Physical Layer Link Aggregation

Matt Squire

Summary of Current Draft

High Overhead – Number of pairs

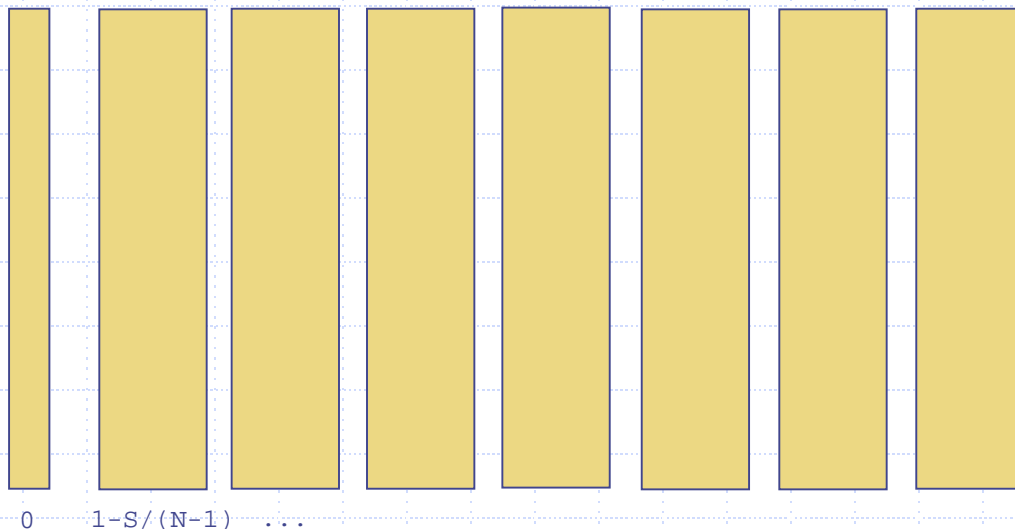
Why 32-pair?

- Seemed like a half-decent number in Raleigh
- It's a power of 2! Utilizes a binary number space
- Vast majority of support focused on 2-4 pair
- 16 is a big stretch for real deployments
- 32 is pulling a muscle, and not in a good way
- 32 pairs span across at least 2 bundles
 - How likely is that?

Proposal:

- Limit maximum number of supported pairs to 24 (one binder group)
- Note that proposed header does not limit via #fragments field, only limited by sequence number space
